APPEAL SUMMARY

Appeal ID: 24867	Project Address: 7000 NE Airport Way
Hearing Date: 5/12/21	Appellant Name: Tara Lund
Case No.: B-007	Appellant Phone: 5032261285
Appeal Type: Building	Plans Examiner/Inspector: David Bartley
Project Type: commercial	Stories: 3 Occupancy: A-3, B, S-1 Construction Type: Type IA
Building/Business Name: Port of Portland - PDX	Fire Sprinklers: Yes - Throughout
Appeal Involves: Alteration of an existing structure	LUR or Permit Application No.: 20-124057-STR-01-MG
Plan Submitted Option: pdf [File 1]	Proposed use: Airport

Appeal item 1

ENPLANING TERMINAL PLAN

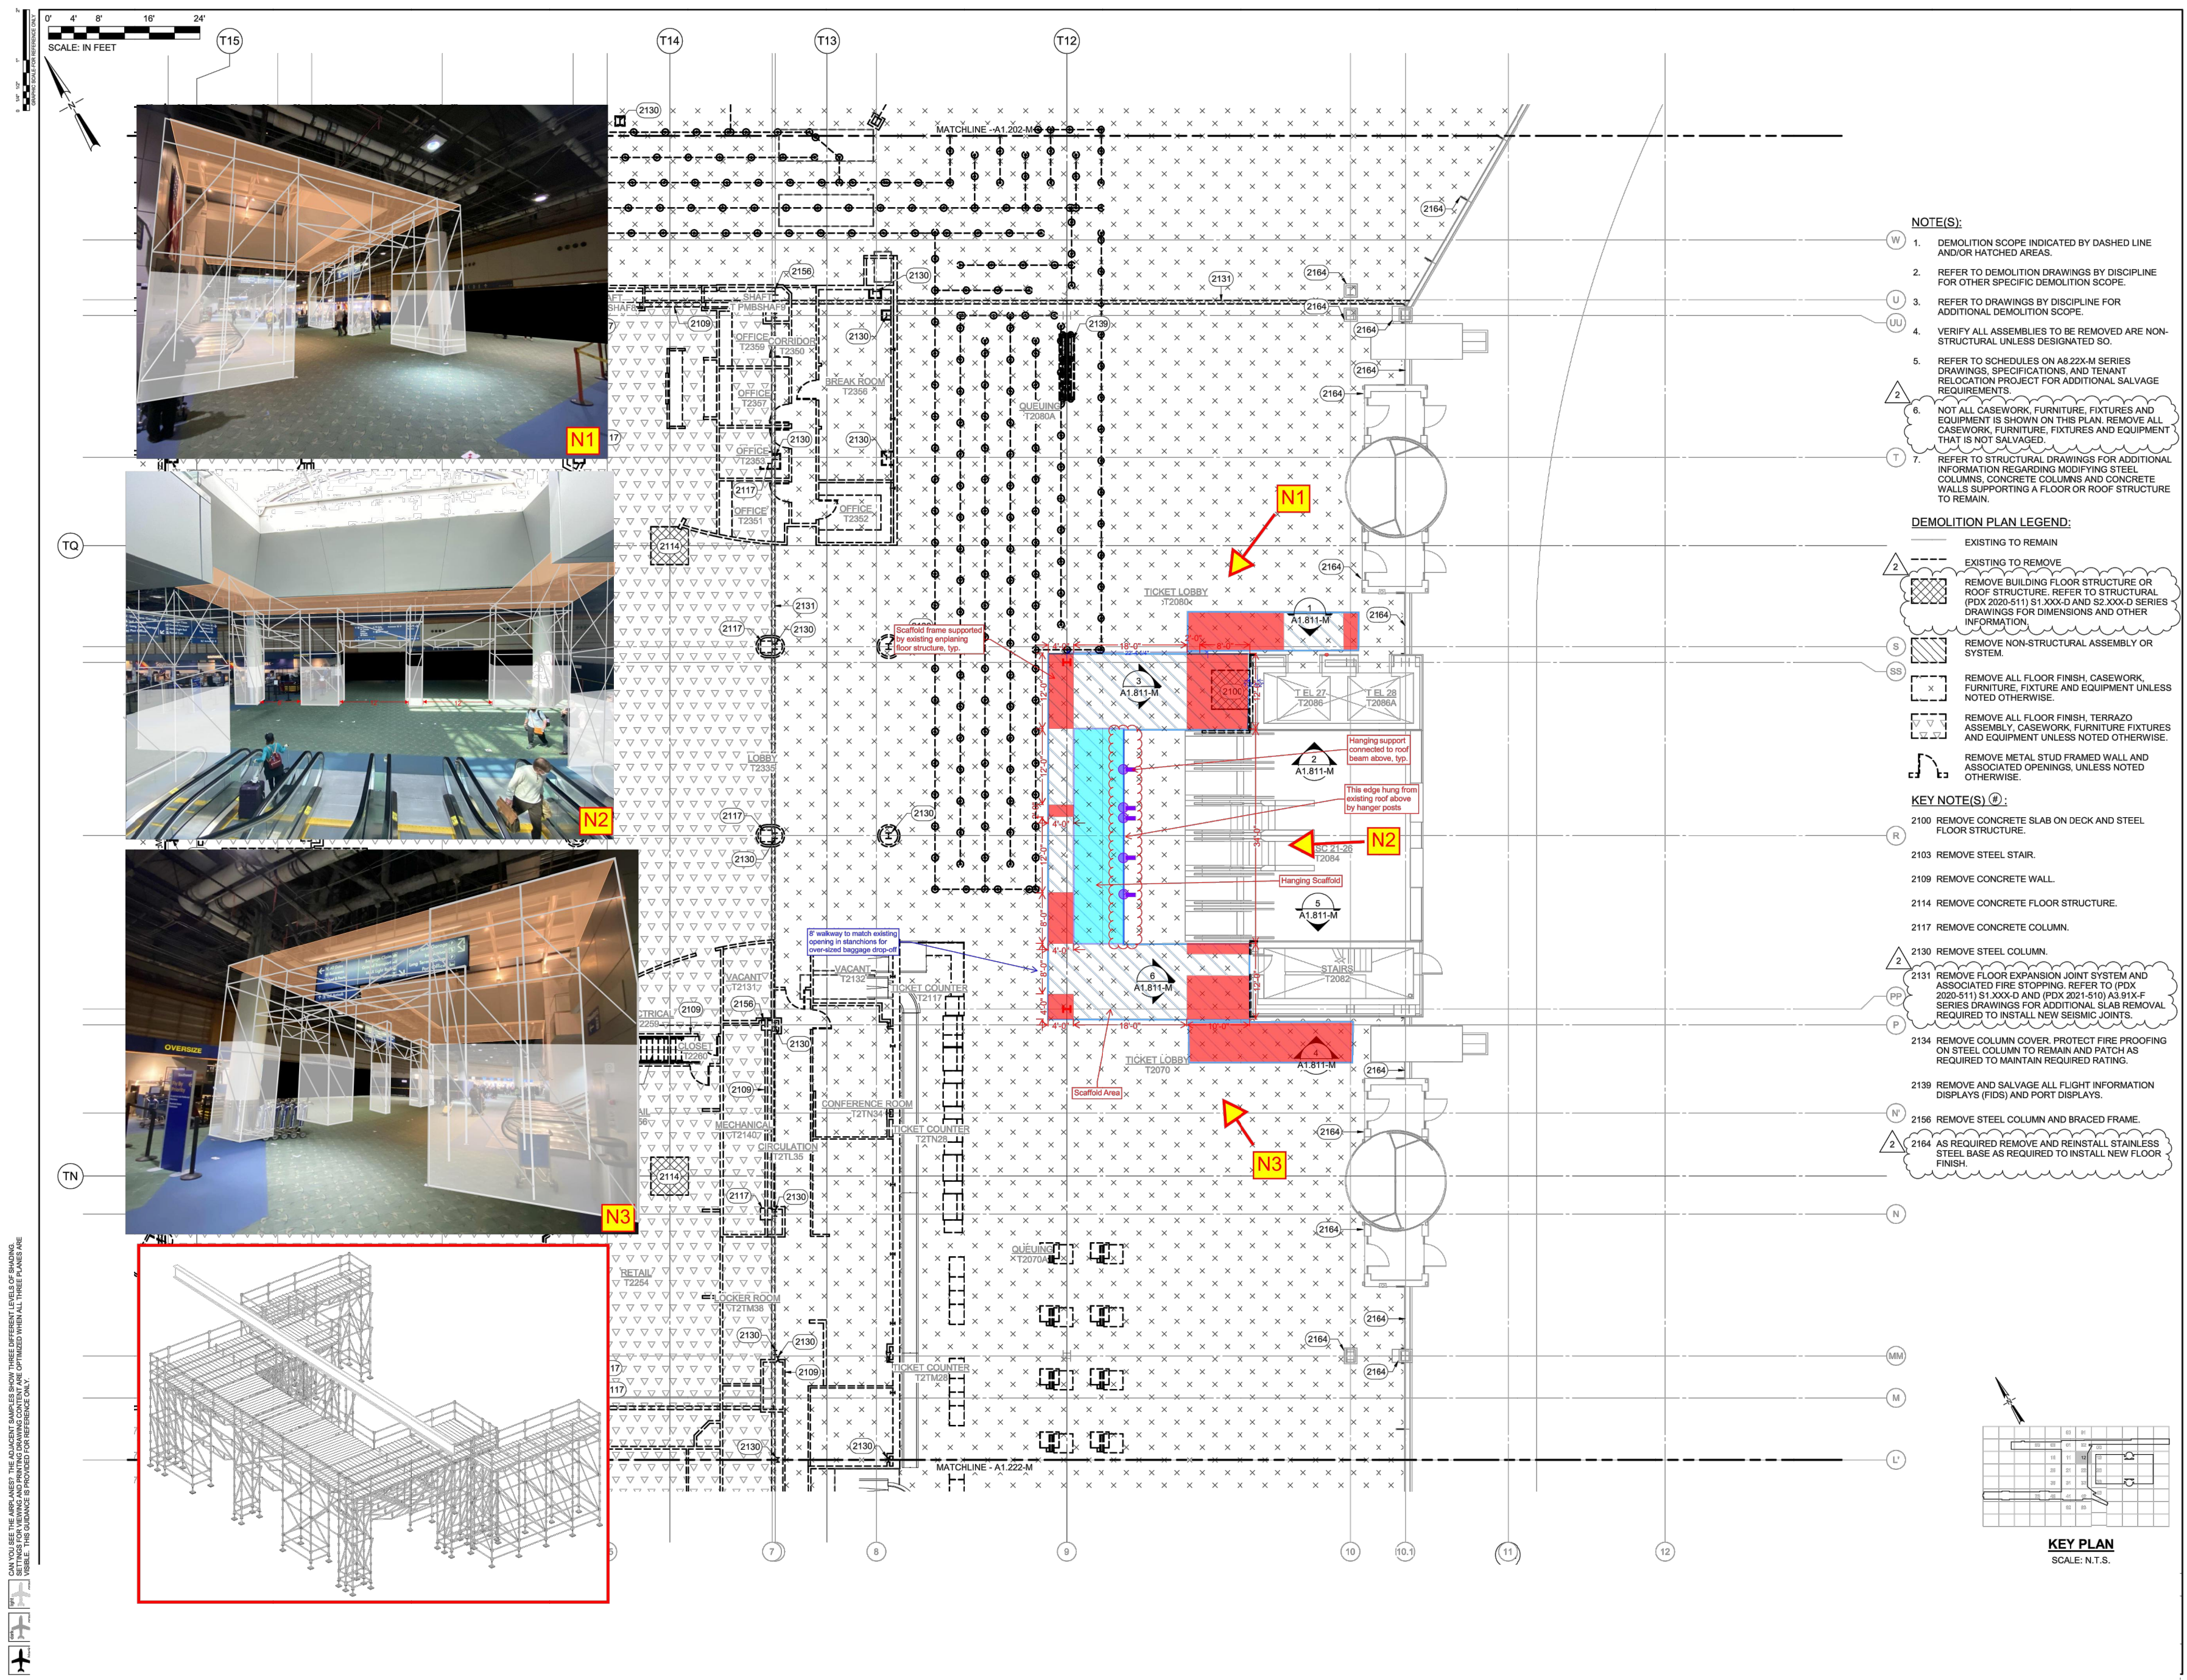
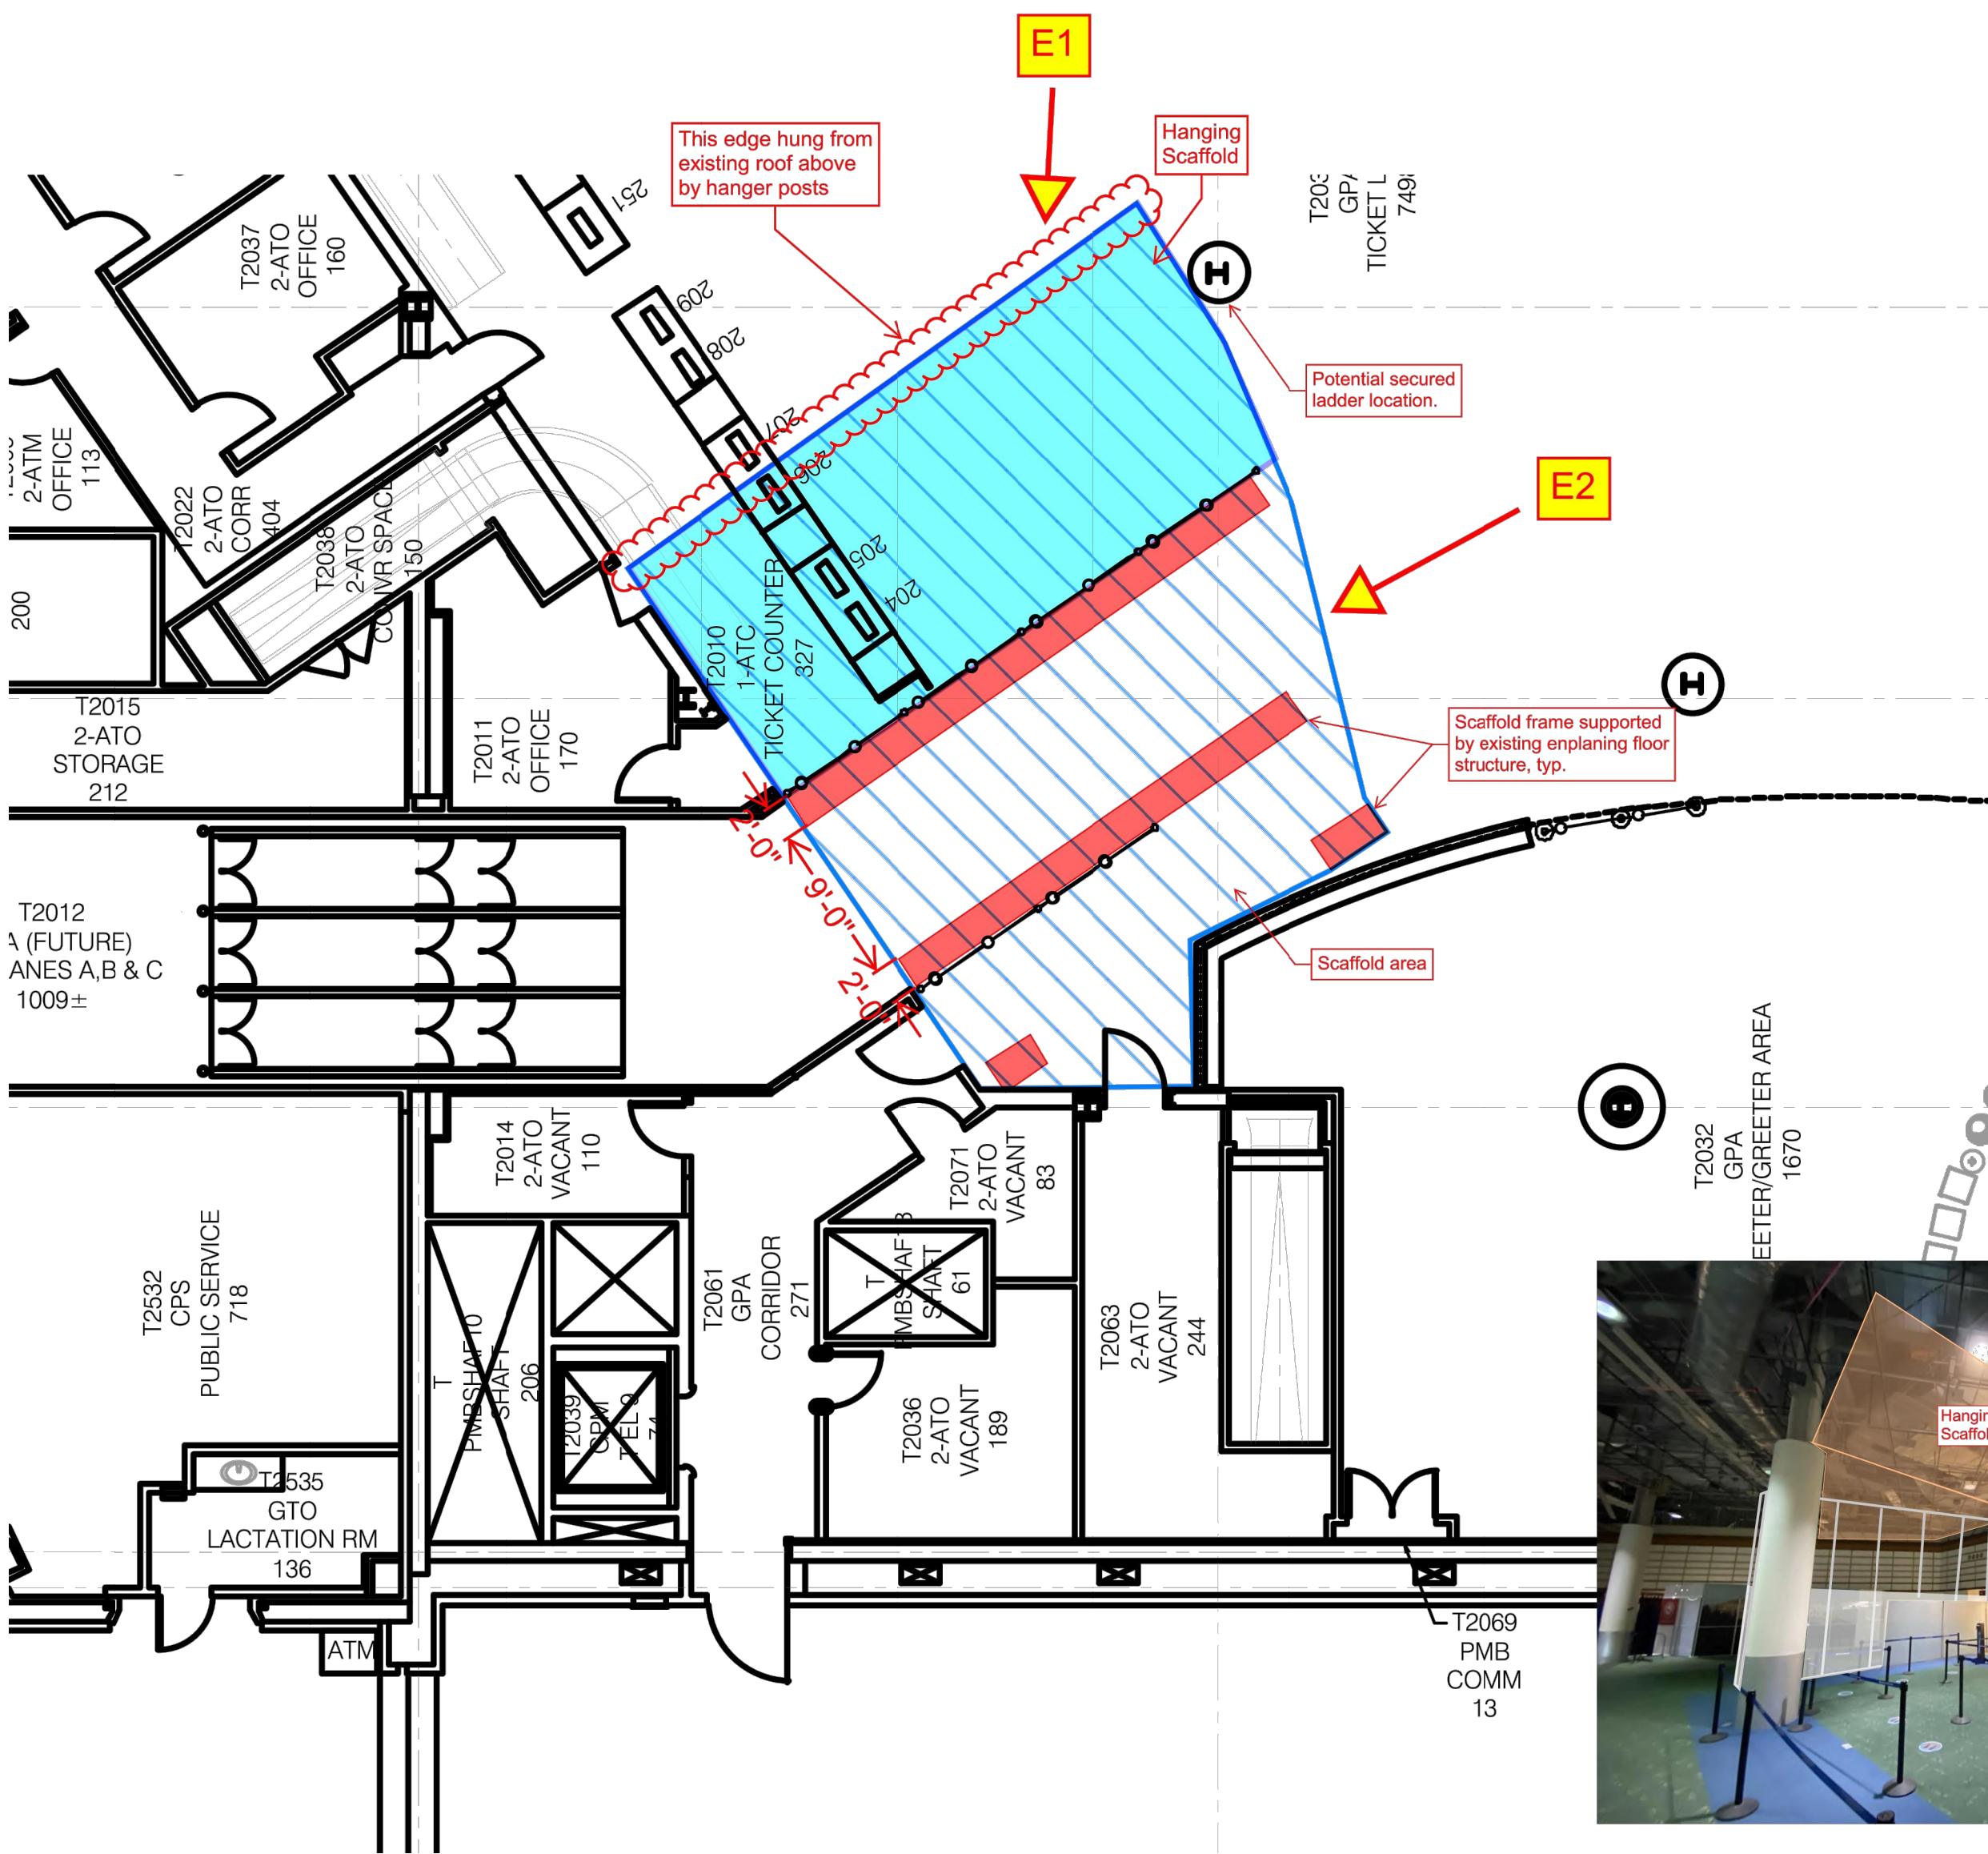
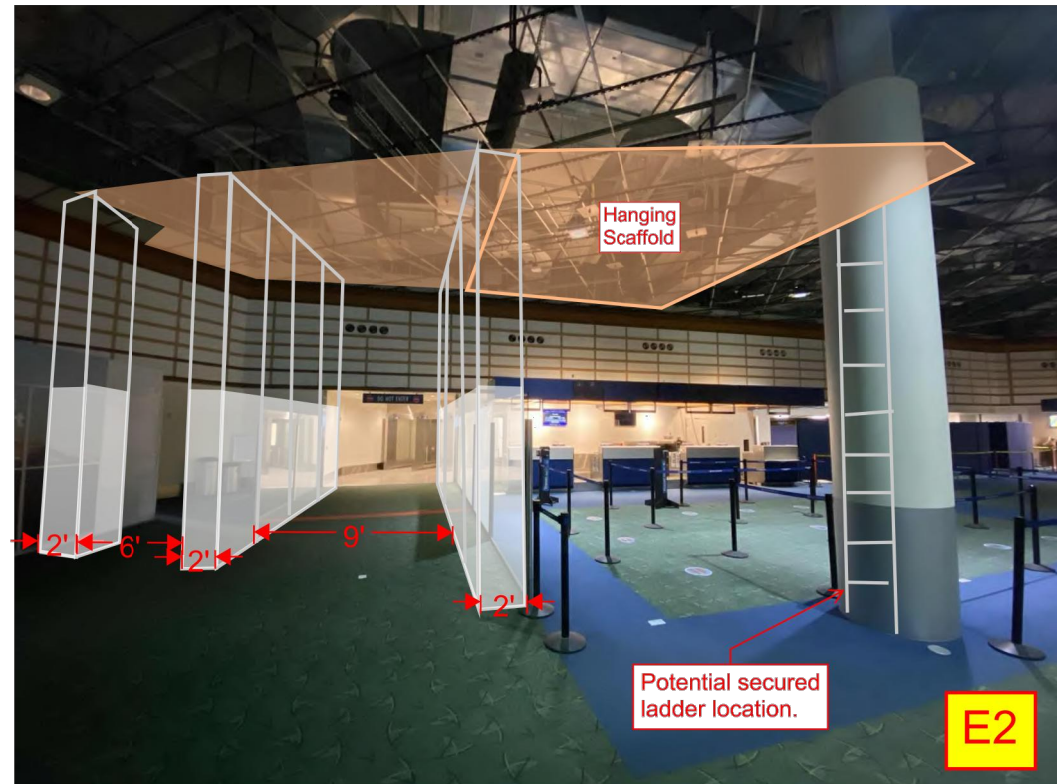
The scaffolding work platform will be roughly 19' above enplaning floor and the area of work will range 10'-0" to 15'-0" above the work platform. The platform will have netting, guardrails and toe boards as required to meet OSHA standards. Any work that involves heavier construction elements, including movement of rain drains, will take place during the night shift with the area below vacated of all non-construction personnel.

Modification to the minimum scaffold live load requirement: Granted as proposed.
